Fast Prototyping Board for RA2E2 Microcontroller
Group
FPB-RA2E2
Errata

Renesas RA Family
RA2 Series

FPB-RA2E2 – Errata

Figure 1. MCU Pin Header J3 Pin 32 Silkscreen Error

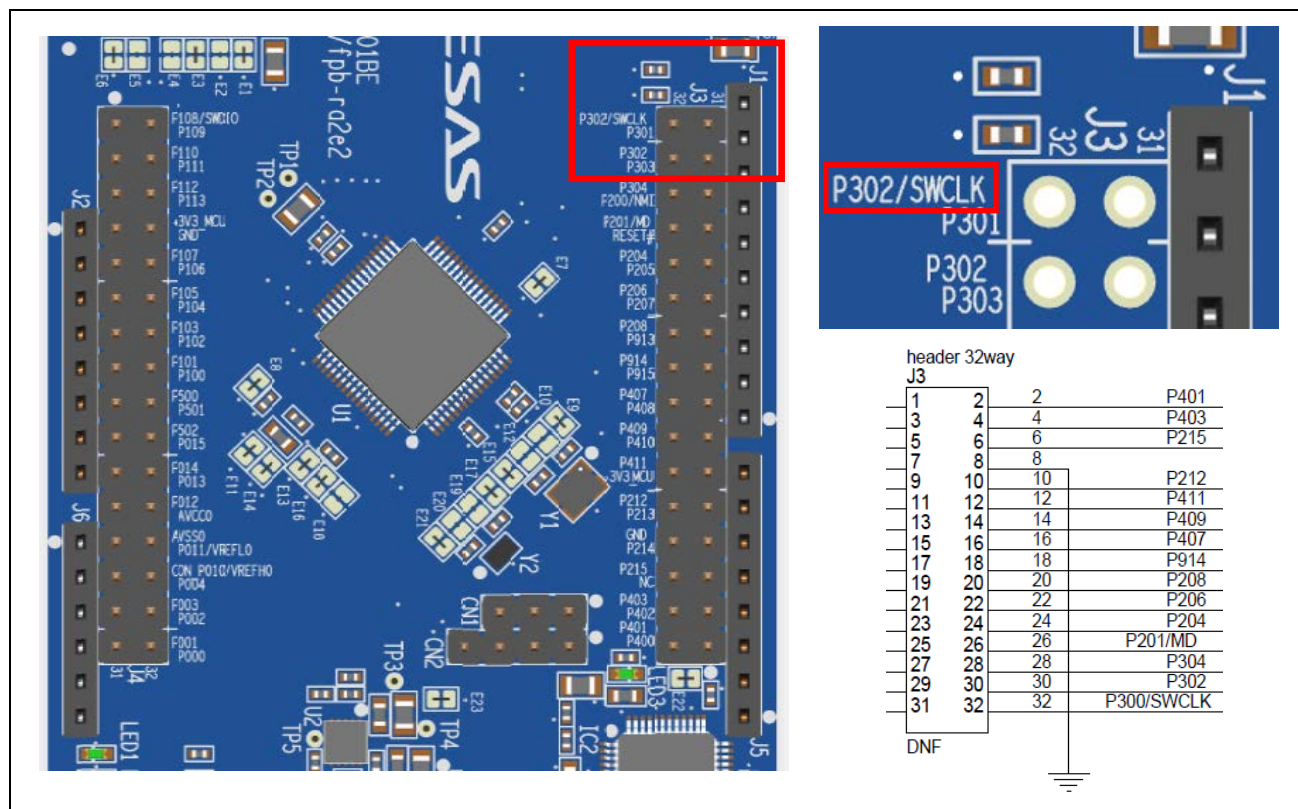
The MCU Pin Header J3 has an incorrect label for pin 32. This is identified as P302/SWCLK when it should be P300/SWCLK. The schematic is correct.

None. The silkscreen has been corrected to show the correct pin identification on later builds of the board.
